ZONING AMENDMENT, PLANNED UNIT DEVELOPMENT & SUBDIVISION STAFF REPORT

NAME Haken Holdings

SUBDIVISION NAME Jaguar Cottages Subdivision

LOCATION 5803, 5807, 5811, & 5812 Waltman Lane

PROPOSED SITE PLAN

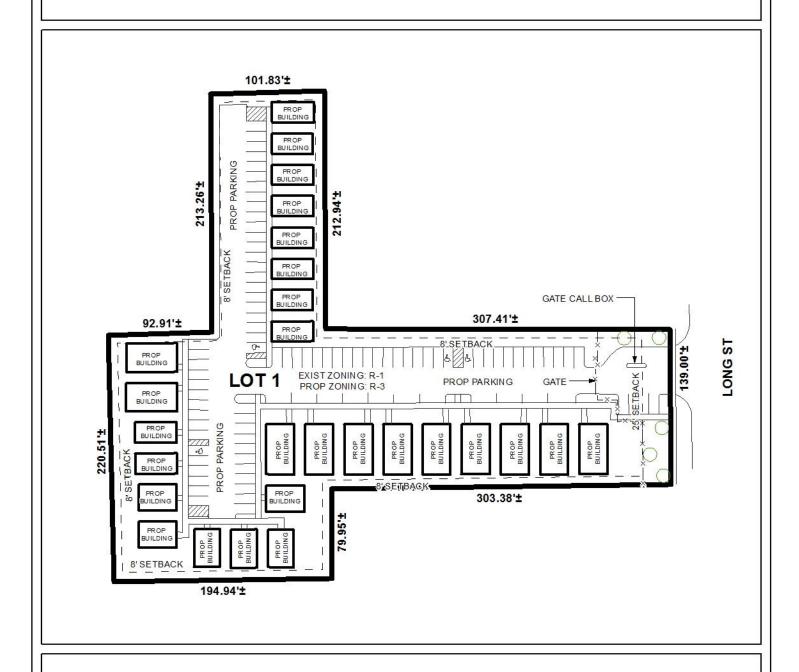
The site has frontage on Long Street, which is a minor street with curb and gutter, and has a compliant existing right-of-way of 50 feet, making no dedication necessary. The site plan submitted illustrates a sidewalk along Long Street, and should be retained on the site plan, if approved.

The preliminary plat does not depict the 25' minimum building setback line along Long Street. If approved, the Final Plat should be revised to depict the setback.

The site plan includes information regarding landscape area and tree plantings. It appears that the site will have a shortage of front landscaped area; however the Planning Commission does have some flexibility with Planned Unit Developments, and may waive this requirement. The proposed layout exceeds the minimum amount of total landscape area, as well as the minimum amount of open space for multi-family residential PUDs per Section 64-5.C.2.c. of the Zoning Ordinance. The site plan indicates that a compliant number of frontage trees will be planted, and that "perimeter and parking trees will be installed per guidance by the Urban Forester or City Ordinance".

The site is located within the area impacted by the amended multi-family parking requirements adopted by the City Council in 2015. The amendment requires "One (1) space per bedroom plus 10% of the total amount of spaces" for the development, which staff calculates to be $82 \times 1.1 = 90.2$, or 91 required parking spaces. It appears that the site will provide 95 parking spaces, thereby exceeding the minimum required amount.

The site plan indicates that a 6' high fence will be provided around the perimeter of the site with a gated entrance, but does not specify what type of fence. If approved, the site plan should be revised to indicate the type of fence. The site plan illustrates that three compliant queuing spaces will be provided between the gate and the front property line, and should be retained on the site plan, if approved. A pedestrian gate is provided to allow access from the proposed development to Long Street.

A sidewalk is illustrated along the frontage of Long Street, and should be retained on the site plan, if approved.

It should be noted that the City of Mobile does not provide curb side pickup for commercial or multi-family developments. A note on the site plan indicates that individual trash cans will be utilized for the cottages. However, if the applicant decides that a dumpster is desirable, the site will need to come back to the Planning Commission.

- 1) Retention of the 25' minimum building setback line along Long Street;
- 2) Placement of a note stating the site is limited to a single curb cut to Long Street, with the size, location and design to be approved by Traffic Engineering and conform to AASHTO standards;

- 3) Retention of the sidewalk along Long Street;
- 4) Retention of the note on the site plan stating "perimeter and parking trees will be installed per guidance by the Urban Forester or City Ordinance";

- 5) Revision of the site plan to indicate what type of fence the "6' fence" will be;
- 6) Placement of a note on the site plan stating the if a dumpster is desired instead of curb side pickup, the site will need to come back to the Planning Commission
